**PLAN COMMISSION / ZONING BOARD OF APPEALS  
AGENDA**

**Project:** Sparks Coffee Co. – New Construction  
**Meeting Type:** Public Hearing  
**Request:** Major change to PUD, Special Use Permits (4)  
**Location:** Hickory Creek Marketplace, Outlot 1E  
**Applicant:** Aliana Winkle  
**Prop. Owner:** Winkle R E Properties  
**Representative:** Applicant  
**Staff report by:** Christopher Gruba, Senior Planner

## **Major changes to plans since workshop**

1 EAST ELEVATION  
1/4" = 1'-0"

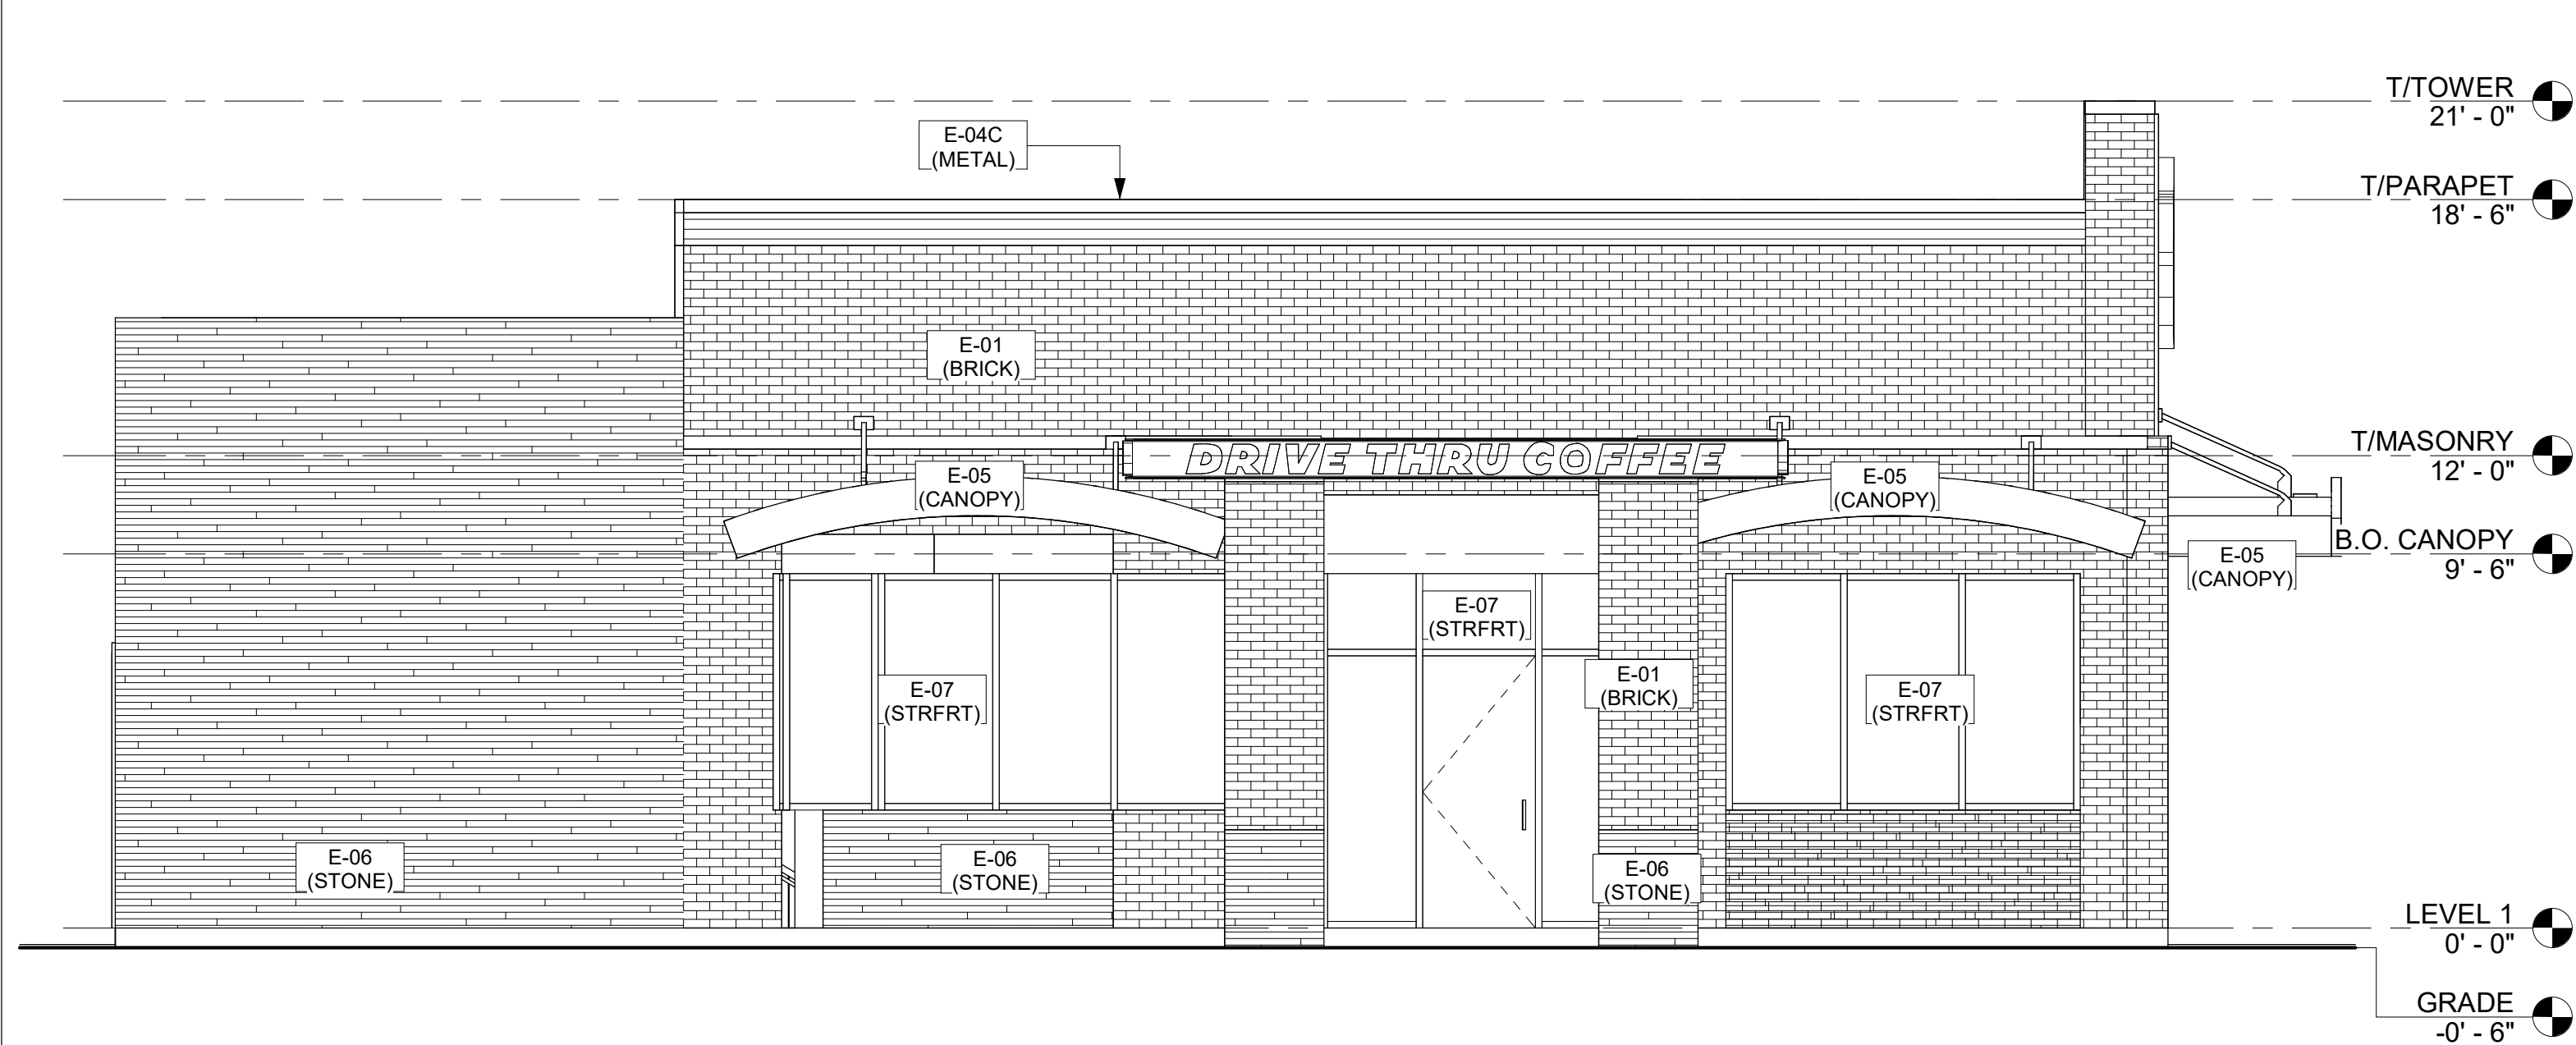
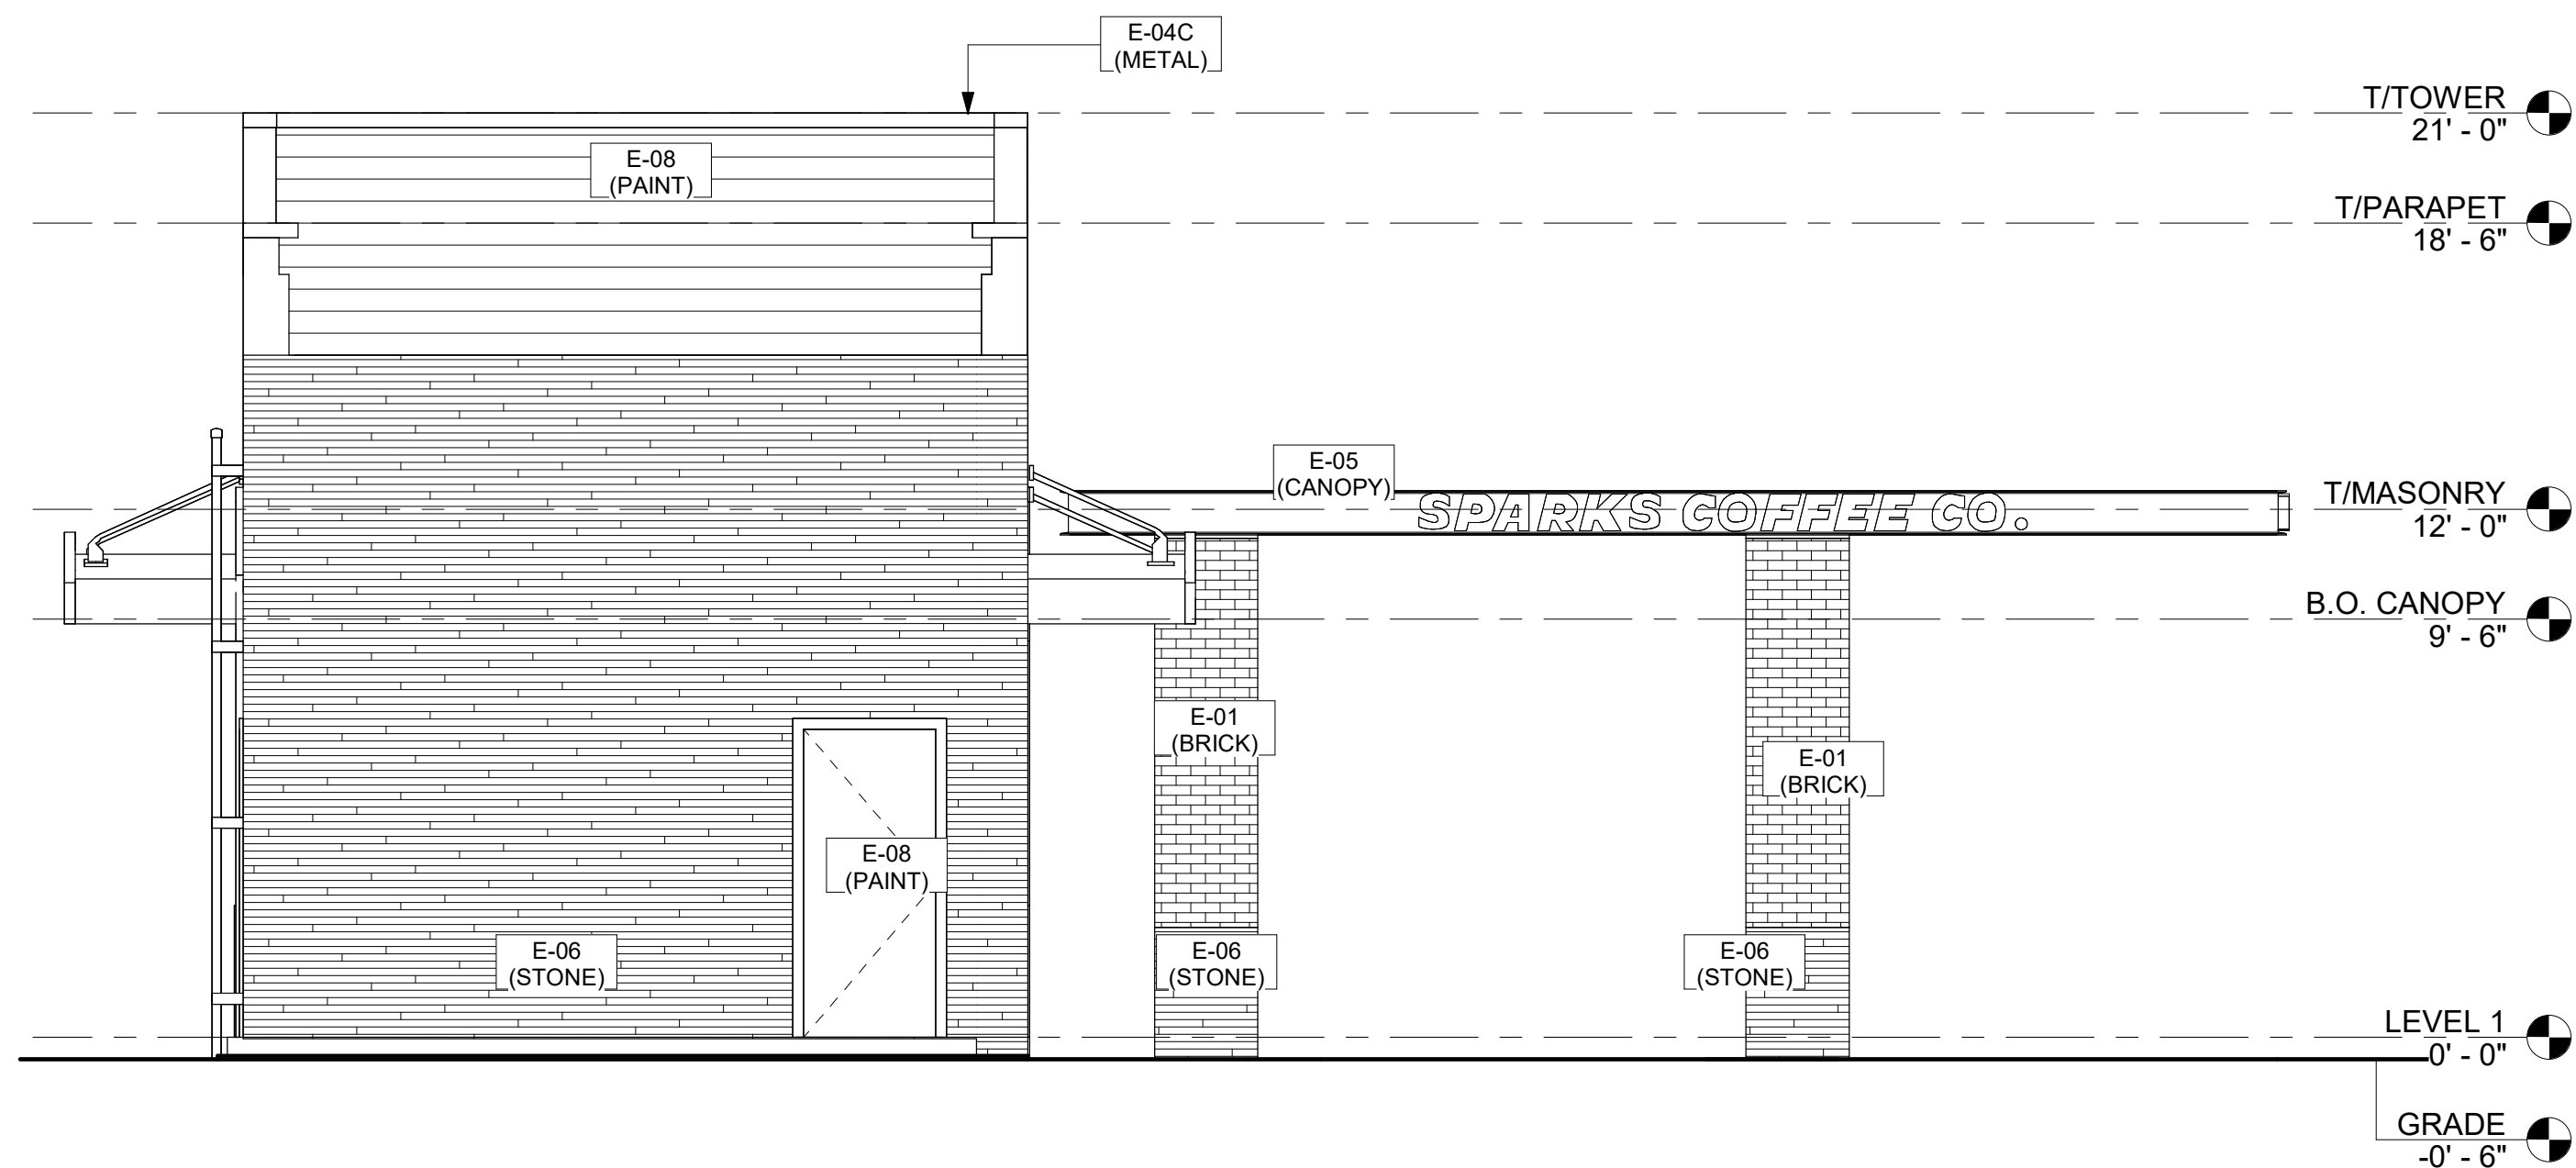
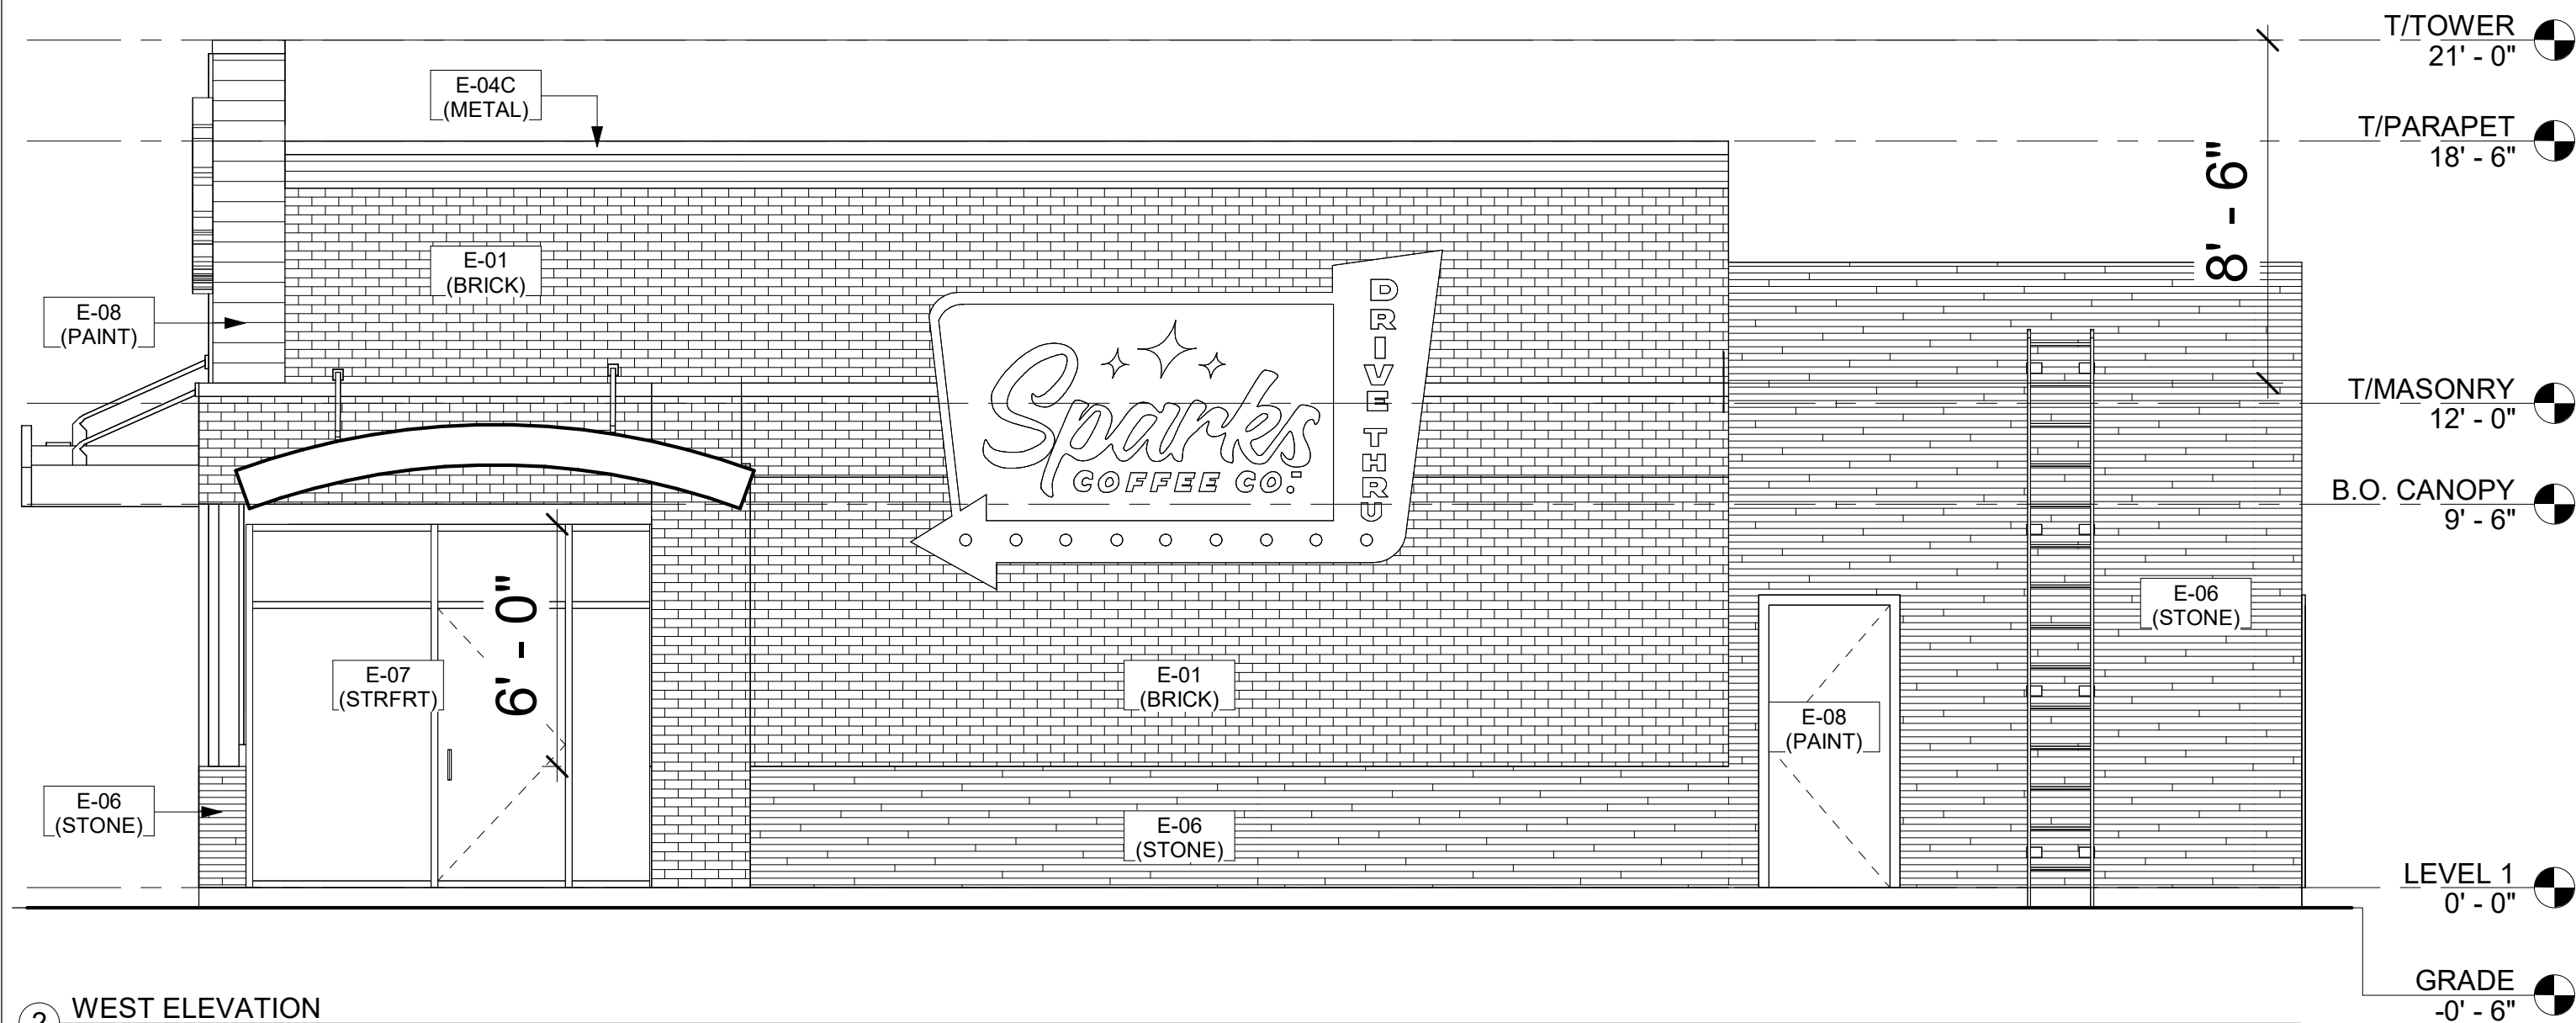
5. A roof access ladder is attached to the west of the building facing La Grange Road.
6. Historically, the Village has not permitted the use of thin brick on buildings. Sheet A300 notes the use of thin brick. Consistent with other recent commercial projects, staff recommends that the Plan Commission/Zoning Board of Appeals condition any approval on the use of standard dimensional brick.

4. Recommend to the Village Board to approve the Major Change to a PUD, in accordance with the reviewed plans and public testimony, conditioned on final engineering approval, using standard brick instead of thin brick on the building and the following exceptions:
